CPA 2022-00012

November 14, 2023

**Re: Small Brothers Corkscrew Commercial Utility CPA
Comprehensive Plan Amendments CPA2022-00012 / CPA2022-00013– *Submittal 2***

Figure 1: Drawdown Contours of Proposed Irrigation Well.

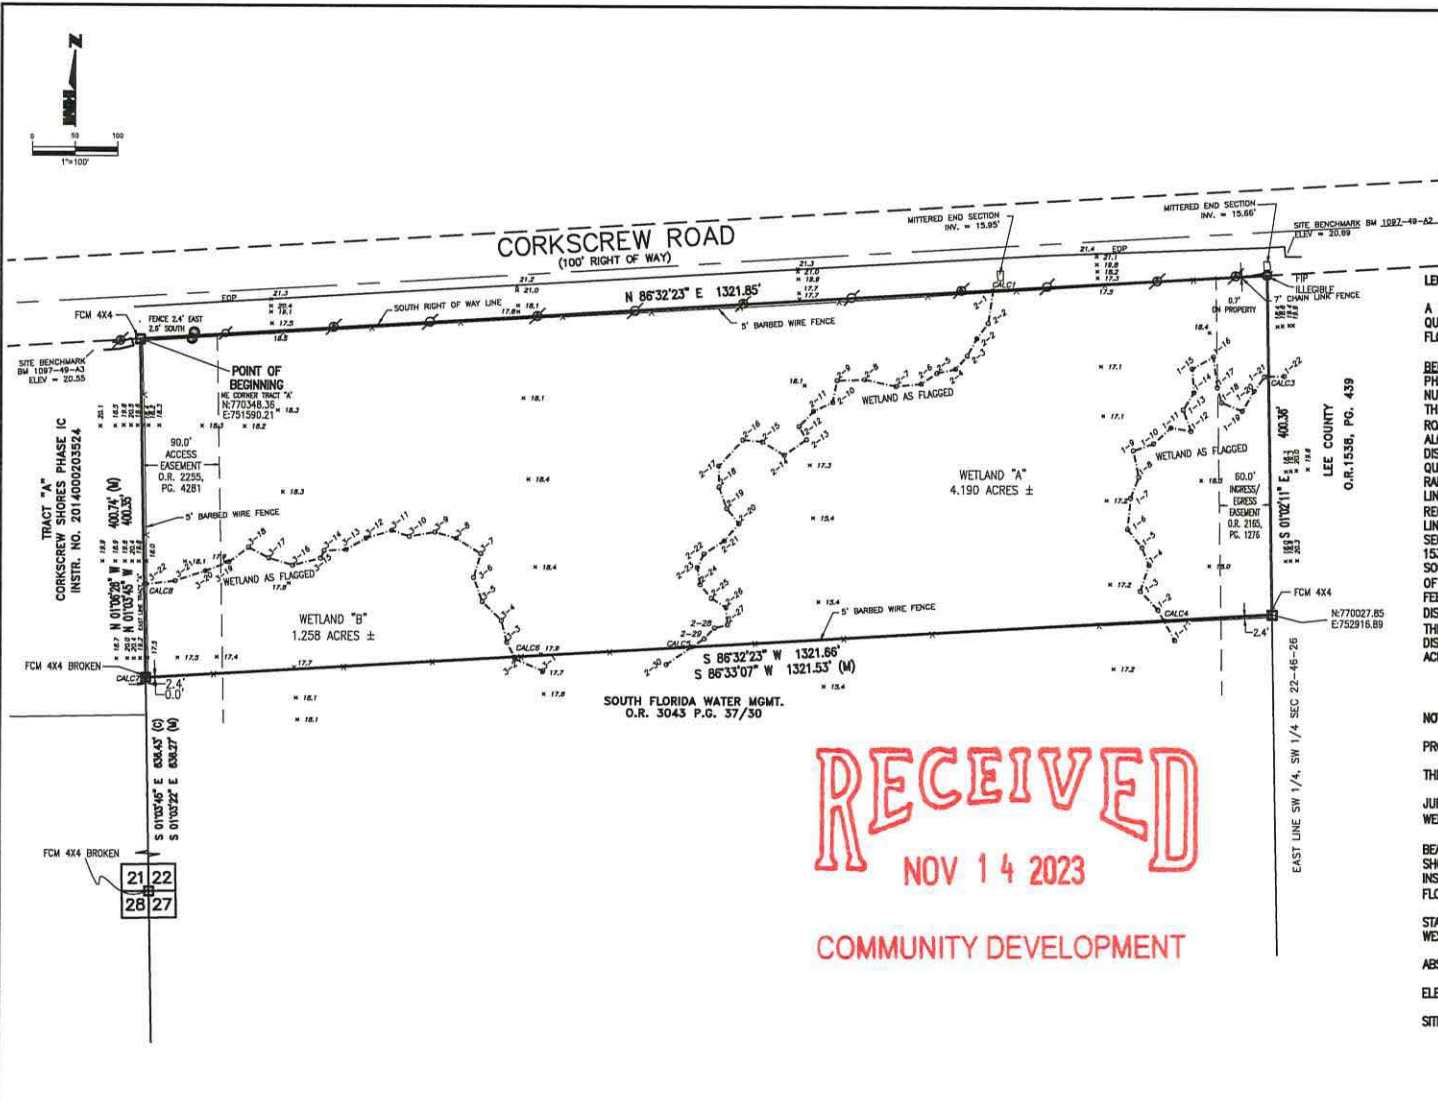
9. Please provide the groundwater model results including water level contours resulting from a maximum water withdrawal for 90 days with no recharge. Please detail which well and what qualifying dry season water level was used for the model. It is understood the applicant is proposing to utilize stormwater lakes as a primary irrigation source. What water source will be used to resupply the stormwater lakes in the event of a drought? How will the proposed resupply source impact the adjacent public supply wells?

Response: Figure 1 below shows the maximum extent of drawdown resulting from a maximum withdrawal of 20,000 gpd from the Mid-Hawthorn Aquifer. This will be used as the primary source of irrigation for the project and will be permitted in accordance with South Florida Water Management District rules. The adjacent public supply wells, which withdraw from the Water Table and Sandstone Aquifers, are not anticipated to be impacted by the withdrawals of this project in the Mid-Hawthorn Aquifer. Stormwater lakes are no longer proposed for the project.
